**BOARD OF ZONING ADJUSTMENT
STAFF REPORT****Date: March 2, 2020****CASE NUMBER**

6312

Brian Ward

3805 Spring Hill Avenue
(Southeast corner of Spring Hill Avenue and North
McGregor Avenue)

SITE PLAN

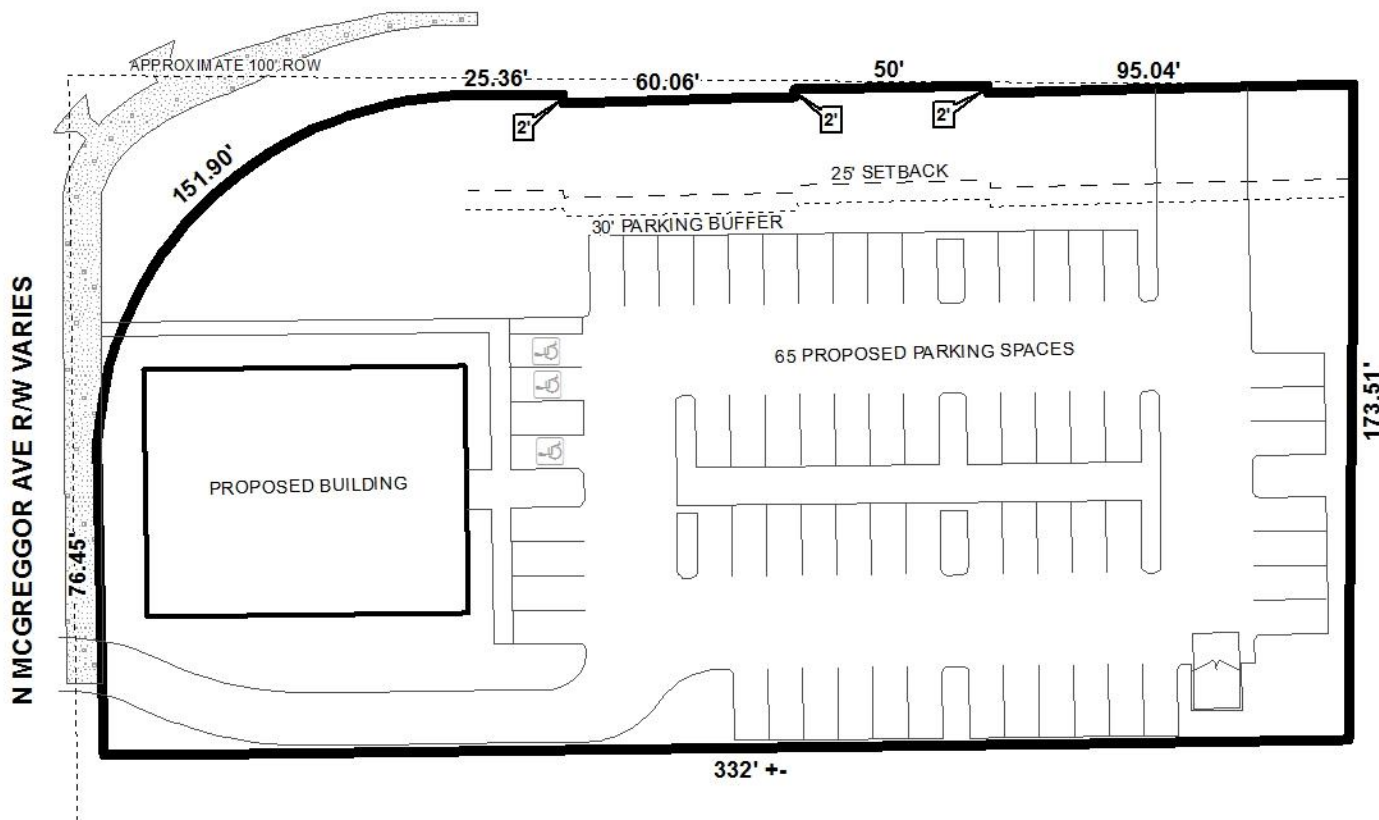
The site is located on the intersection of McGregor Avenue and Spring Hill Avenue. The location of the proposed 6' tall garden wall was not identified on the Site Plan provided. According to other documents submitted to support the application, the applicant has agreed to locate the garden wall a minimum of 12' behind the sidewalk shown which is acceptable to Traffic Engineering.

Regarding the building standards, as illustrated on the plan, the site is located at the intersection of Spring Hill Avenue a major street, and the right turn lane from McGregor Avenue to Spring Hill Avenue. This turn lane creates a large radius which may preclude the construction of a building to the property lines; consequently, the applicant has selected to move the building closer to the McGregor Avenue property line, at the beginning of the radius. However, allowing for the curve, the building is also unable to shade the sidewalk.

Regarding the 70% build out requirements; the property has 75 feet of frontage on McGregor, 230 feet of frontage on Spring Hill, and 150 feet of frontage on the radius. Compliance with the build out requirements would demand a building that is 318 feet long by 17 feet deep in order to provide the applicant with the square footage needed and comply with the build out requirements; this may indicate a hardship exists to comply with the build out standards.

Regarding parking, there are two issues at hand. First the applicant proposes 65 parking spaces; however, the TCD standards prohibit provision of parking exceeding 20% of the minimum required parking. In this situation, the minimum required parking for a 5,395 square foot building is 12 spaces; with an additional 20% over the standard non-TCD minimum requirement, allowing a maximum of 22 spaces. It should be noted that the parking spacing allocation is always “rounded up” as partial parking spaces cannot be provided. Regarding the requested number of parking spaces, as illustrated in the applicant’s narrative, they are seeking to provide parking spaces for the employees and one visitor.

The applicant proposes to provide a garden wall which is a design element of the TCD standards; however, the TCD standards also requires compliance with Section 64-4D.6. of the Zoning Ordinance which does not allow a fence or wall 3 feet in a front setback; however, as Traffic Engineering has approved the ligustrum planting wall setback 12 feet from the Spring Hill Avenue property line, approval of the garden wall as proposed would seem appropriate.

- 1) Provision of the garden wall as referenced in the application with approval by Traffic Engineering;
- 2) Full compliance with the Engineering Comments: *(1) The proposed improvements shown on the submitted plans will require a Land Disturbance Permit; and 2) Any and all proposed land disturbing activity within the property will need to be submitted for review and be in conformance with Mobile City Code, Chapter 17, Storm Water Management and Flood Control); the City of Mobile, Alabama Flood Plain Management Plan (1984); and, the Rules For Erosion and Sedimentation Control and Storm Water Runoff Control.)*

- 3) Full compliance with Traffic Engineering Comments: *(The site is located on the intersection of McGregor Avenue and Spring Hill Avenue. The location of the proposed 6’ tall garden wall was not identified on the Site Plan provided. According to other documents submitted to support the application, the applicant has agreed to locate the garden wall a minimum of 12’ behind the sidewalk shown which is acceptable to Traffic Engineering); and*
